BULLETIN

Number 87

SUBJECT: PLEXIGLAS WINDSHIELD

TO: OWNERS OF J5A AIRPLANES

FIGURE I

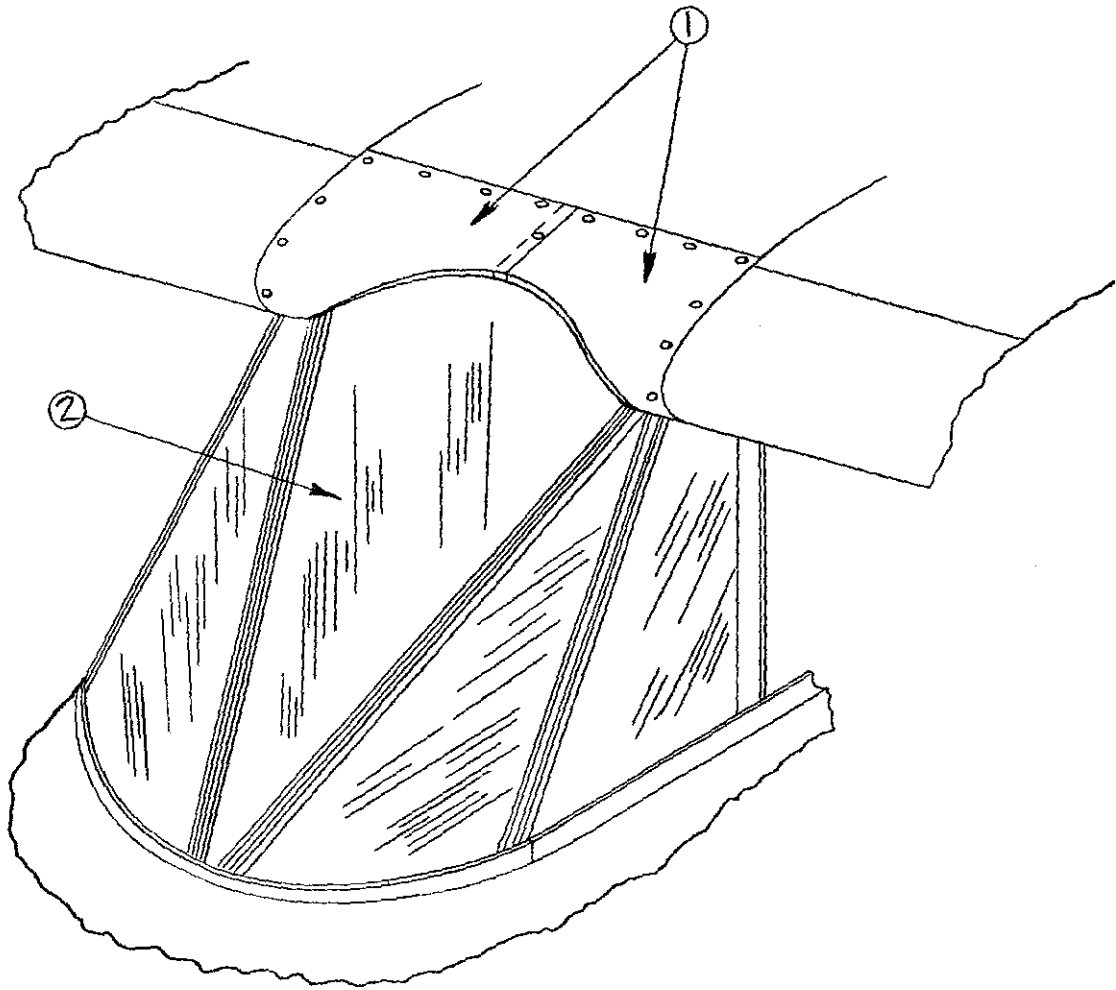
1. Remove the eyebrow fairings (1, Fig. I) and windshield (2, Fig. I).
2. The three 6" pieces of rubber beading (Part No. 81511-11) will be slipped over the lower edge of the windshield and cemented in place, one on either side of the windshield, adjacent to the windshield strip (Part No. 50241-5) and the third 6" piece will be at the front center of the windshield. These strips of beading will prevent the lower edge of the windshield from chafing through the fuselage cowl. (See Section A-A, Fig. II).

FIGURE II

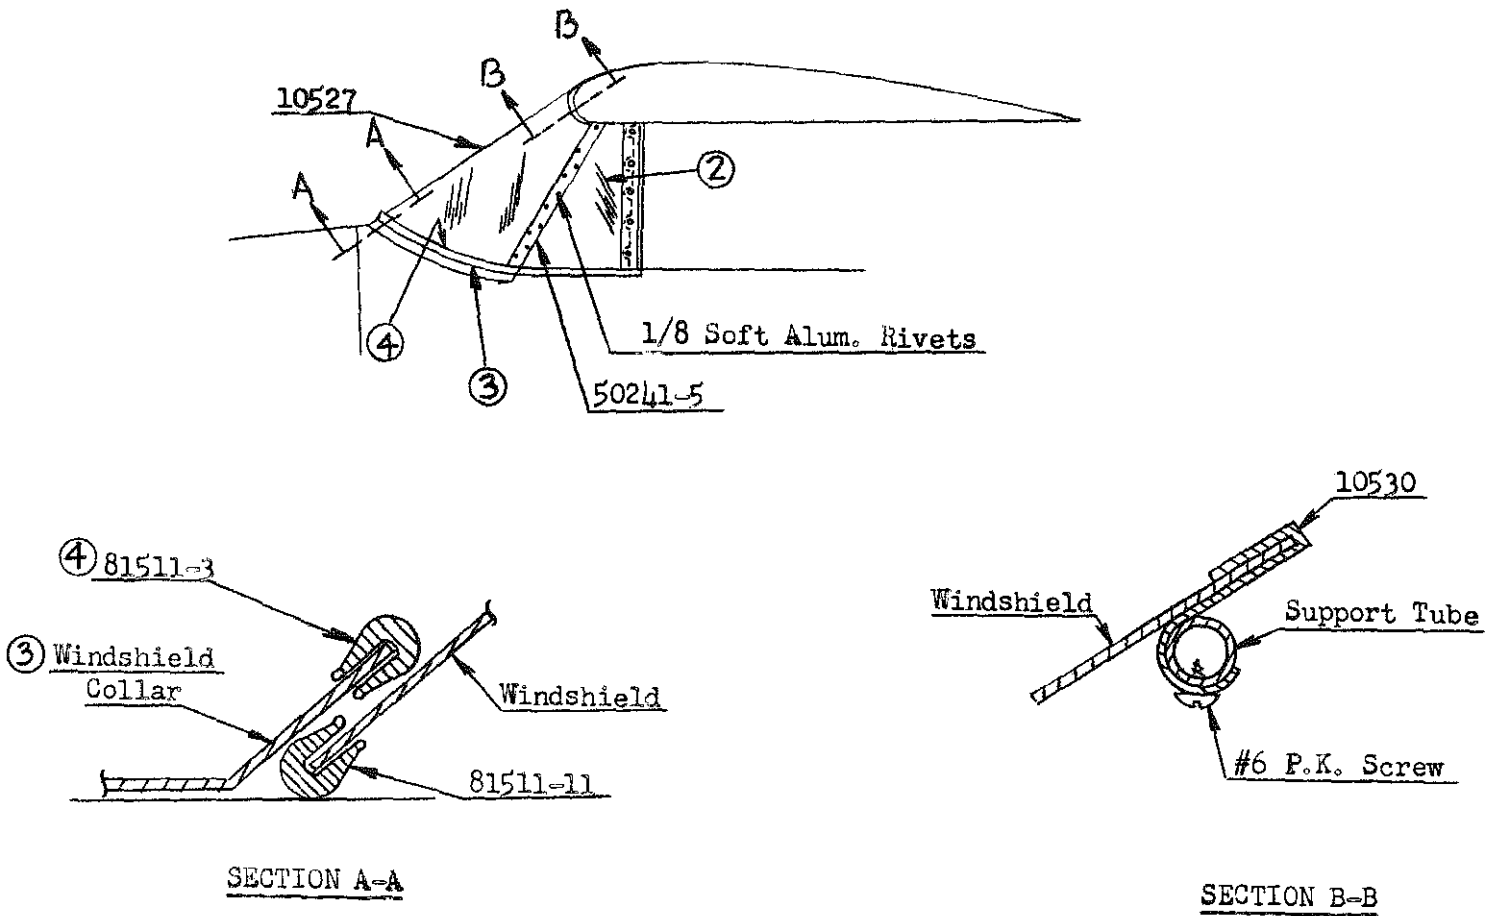
3. The triangular window (2, Fig. II) on the right and left sides are to be replaced by the owner, (using a minimum of .060 pyralin or vinylite). They are attached to the windshield assembly (Part No. 10527) by 1/8 soft aluminum rivets, using 10 on each side. (See Fig. II).

4. The windshield can now be installed by slipping the bottom edge under the windshield collar already attached to the fuselage cowl (3, Fig. II), and attached at the top by means of the two steel clips (Part No. 10530) included in the assembly. The clips will be slipped over the top edge of the windshield, formed around the windshield support tube and attached by means of #6 P. K. screws driven up through the clip and into the support tube at a point near the wire support attached to the fuselage sabane member on the right and left sides. (See Section B-B, Fig. II). The rubber beading (Part No. 81511-3) can now be placed around the windshield collar (4, Fig. II).

5. The triangular window (2, Fig. II) having been attached to assembly No. 10527, may now be drawn back on right and left sides and attached as it was originally on the back and bottom edges.
